# **Attachment E**

Regarding DA Notification: D/2023/862 - 117 Victoria Street POTTS POINT NSW 2011

I am writing to you regarding the proposed development at 117 Victoria Street, Potts Point  
**(DA reference D/2023/862)**

Image 1

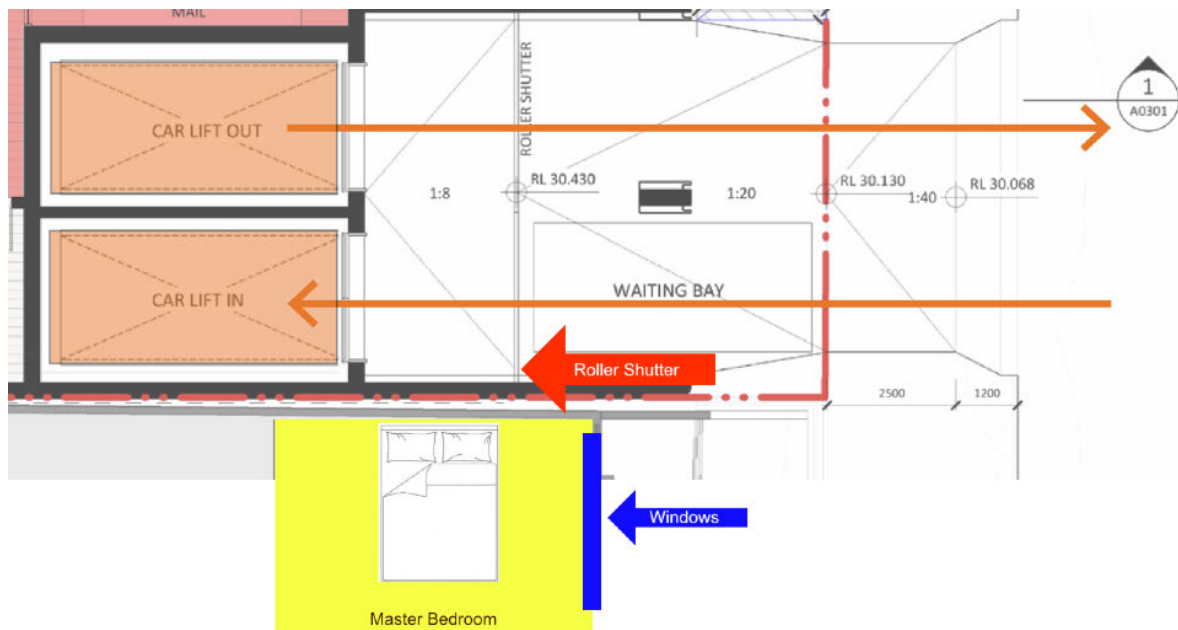
- The proposed development will have a significant day-to-day noise impact:
  - The developer is proposing to have two car lifts and roller shutters (see images 1 and 2 above) to provide access to basement level parking. The proposed location of these is directly next to the master bedrooms for the apartments of 119 Victoria Street (as shown in image 2). Noise that will be generated from the machinery for the roller doors and of the car lifts, particularly at night, will be right next to these master bedrooms causing significant disturbance and interrupting sleep.

- Additionally, noise and exhaust fumes from cars and particularly motorcycles waiting in the waiting bay for the car lift will be directly next to bedroom windows, (as shown above in image 2), meaning that windows can't be left open due to an increase in exhaust and noise pollution from the idling cars and motorcycles waiting for the lift.

The building should therefore not be permitted to be built so close to our existing building and the waiting bay, roller shutters and car lifts should be set further back.

Image 3

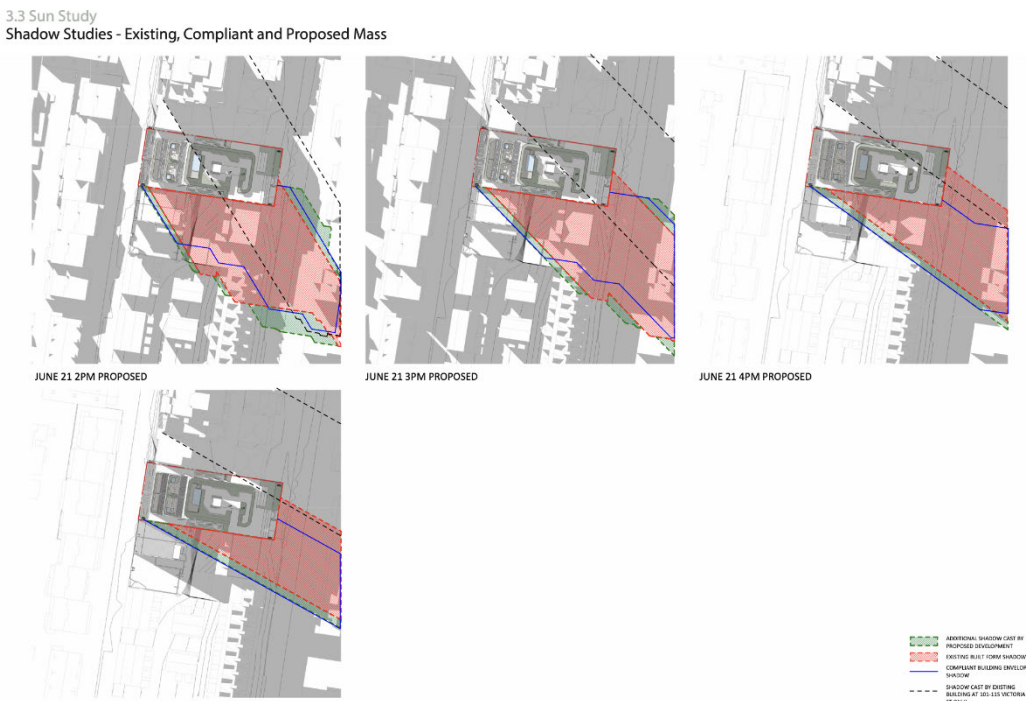
- The windows on the west-facing side of the Victoria Street units are the only source of natural light for the kitchen & living areas. In conjunction with the previously approved development on Brougham Street, the proposed development will have a further catastrophic impact, removing a significant amount of light for our unit. In the winter months, this will result in our unit having a significantly low level of natural light and sunshine. The studies forming the diagram below (image 3), **do not** consider the additional development that was approved on Brougham Street and the subsequent impact on us.

- The proximity of the development, which is planned to be built much closer to our building, and the current design will block airflow through to our unit which combined with the removal of natural sunlight will increase the occurrence of mould and may subsequently lead to health issues.
- The development will result in further overshadowing which will result in decimation of the natural foliage. This in turn will have an impact on the wildlife, such as birds, bats, possums, reptiles, and other animals that are often found in the gardens.

The building should not be permitted to be built so close to our existing building to allow for some light and airflow, taking into account the already approved development on Brougham Street.

Image 4

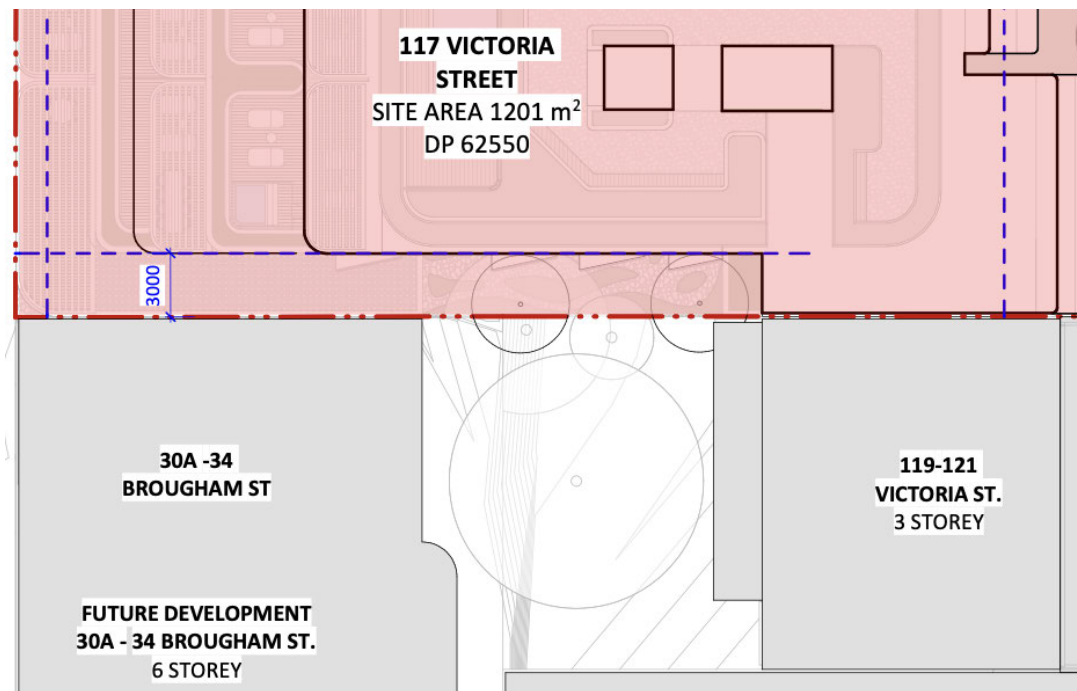
- The communal rooftop open space and reduced proximity to our building will cause excessive noise. Together with the approved development on Brougham Street as mentioned above, the rear of our block will be completely closed in (see image 4 below). With the reduced proximity of the new development to our block, noise from the communal rooftop and pool will therefore be exacerbated particularly as this area will attract groups of people and parties, causing excessive noise into the main living areas of the apartments in our block.

The building should therefore not be permitted to be built so close to our existing building and there should not be a communal rooftop space and swimming pool permitted.

Image 5

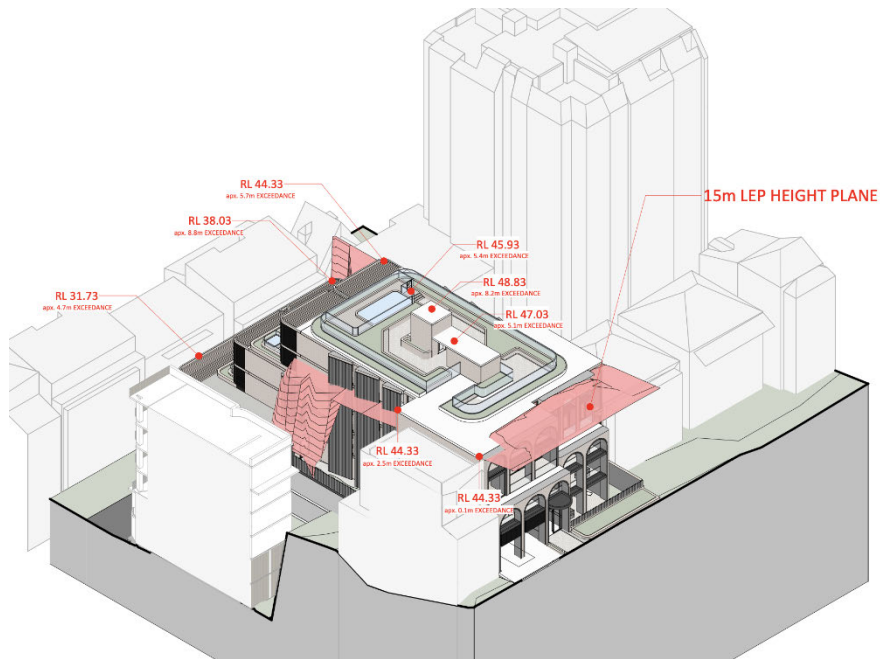
- The proposed development exceeds the legal height limit – The height restrictions exist for a reason and should be enforced. No part of the building should exceed the permissible height limit by any amount (see image 5 below).

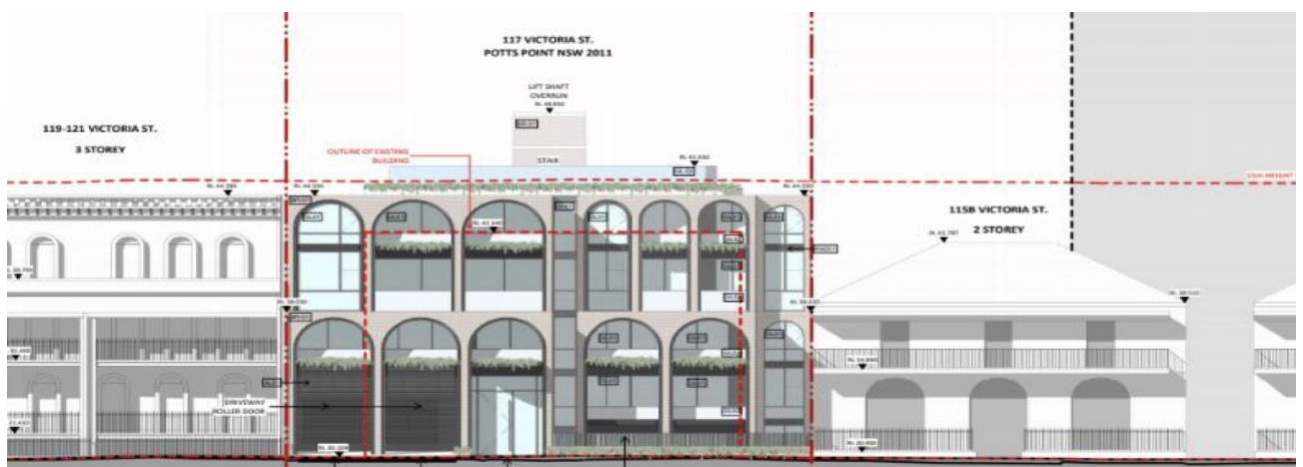
Proposed development illustration below showing building to the boundary and completely blocking all 5 windows on the southern side of our heritage house.
